# SERVICE BULLETIN MAINTENANCE OF WAY EQUIPMENT

| DATE:   | 12-15-2004                     |  |  | BULLETIN NO:                             | 04-012 |
| TITLE:  | SURFACE TRANSDUCER CONVERSIONS |  |  |  |        |

PRODUCT SERIES / MODEL: 6700S Tampers

FIGURE 6

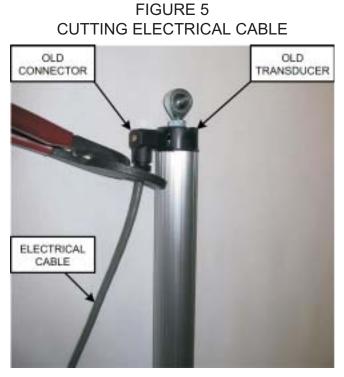
- 5. Strip back the jacket insulation and shielding from the electrical cable as shown in Figure 6 and per the instructions on Conversion Print #2010232.

- 6. Strip back the wire insulation from the electrical cable wires as shown in Figure 6 and per instructions on Conversion Print #2010232.
- 7. Assemble the new 90 degree M12 mating quick connect plug #2010223 onto the end of the electrical cable as shown in Figure 6 and Figure 7, and per the instructions on Conversion Print #2010232.

FIGURE 8 NEW TRANSDUCER INSTALLED

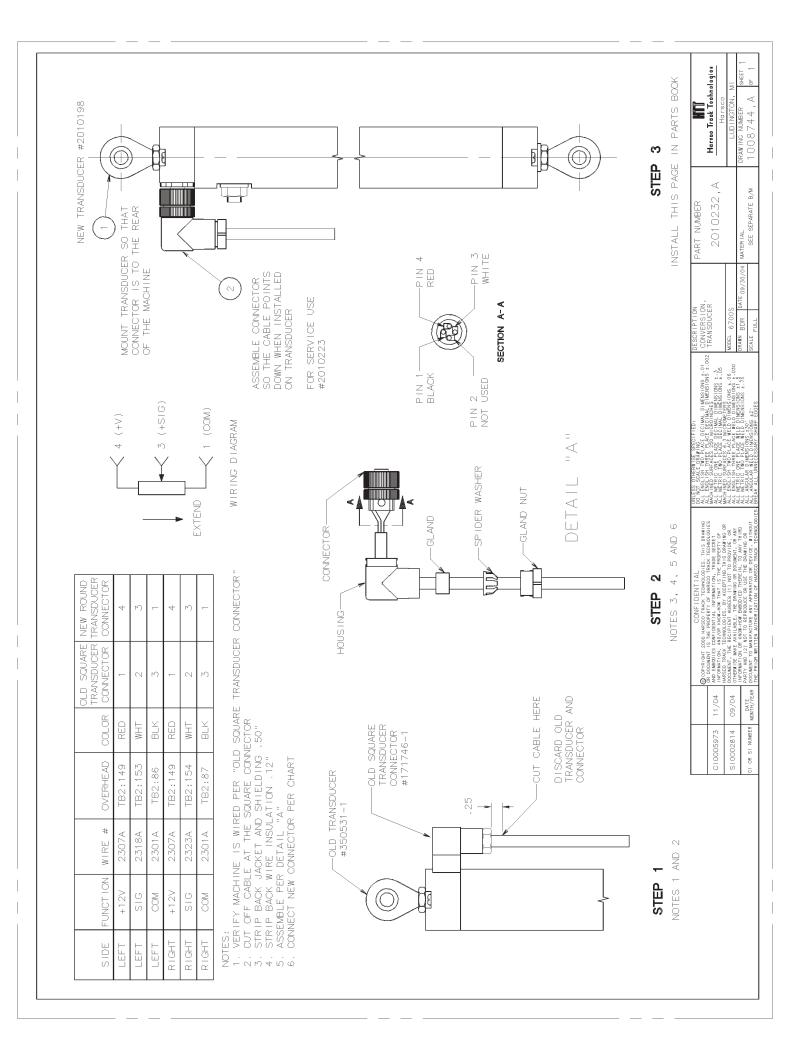
- 8. Install the new transducer.
- 9. Connect the new electrical cable quick connect plug to the electrical connector receptacle on the new transducer as shown in Figure 7 and Figure 8.
